10-16 Seven Hills Road, Baulkham Hills Traffic and Parking Assessment

Prepared for:
Think Planners

30 January 2024

1.4 TfNSW Comments

Figure 2.2: Comparison of Total Traffic Volumes at the Windsor Road-Seven Hills Road-Old Northern Road Intersection in 2019 and 2022

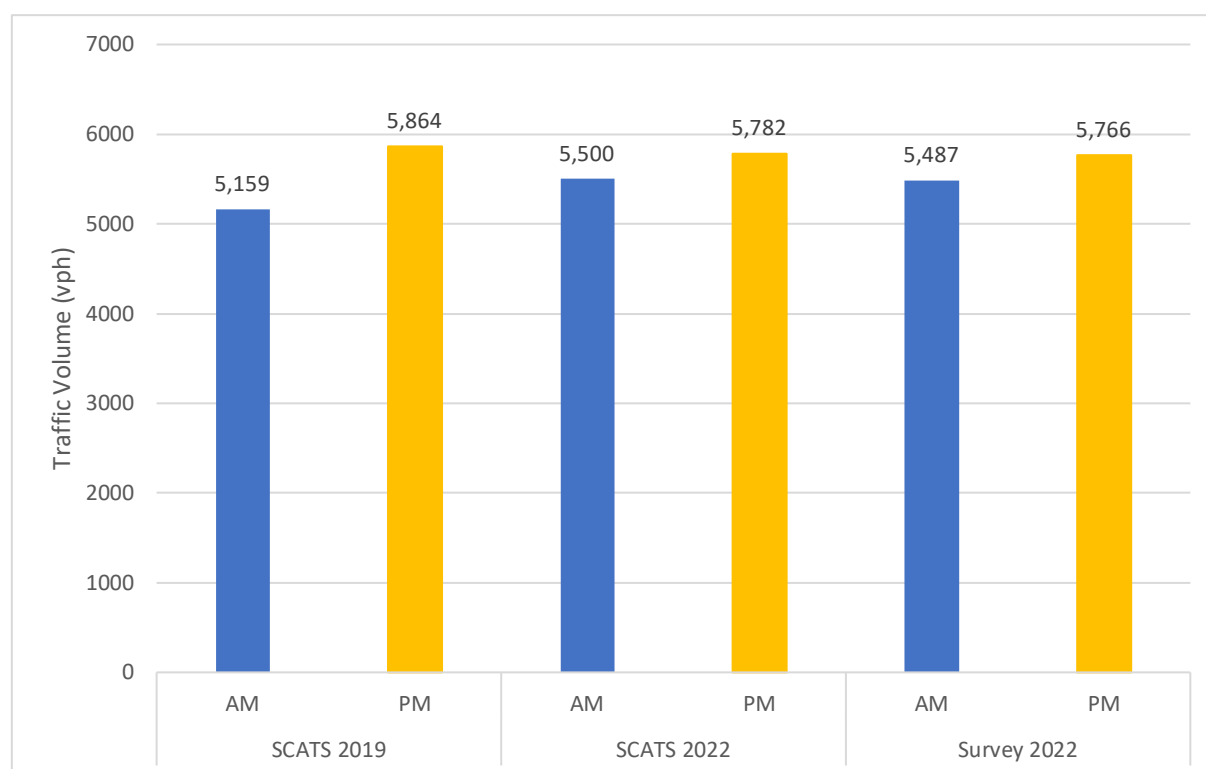
- Page 5: States that *"for consistency purposes, the SCATS 2019 and 2022 data was used to derive adjustment factors for each approach at each intersection respectively for the AM and PM peak hours."* The following questions require clarification:

- Was each approach adjusted to replicate the same volumes as what SCATS reports?
 - Did the model only include SCATS volumes?
 - Show the adjustment factors used and the unadjusted existing traffic volumes.

Refer to Section 2.3 for the Covid adjustment factors applied to the individual traffic movements on the surveyed traffic volumes.

The 2019 and 2022 SCATS data shows an increase of 341 vph during the AM peak and a decrease of 82 vph during the PM peak, indicating the traffic volume in the PM peak has not fully recovered to the year 2019 level. For consistency purposes, the SCATS 2019 and 2022 data was used to derive adjustment factors for each approach at each intersection respectively for the AM and PM peak hours.

TTPP applied the Covid adjustment factors to the 2022 surveyed traffic volume based on individual traffic movements shown in Table 2.3 and Table 2.4.
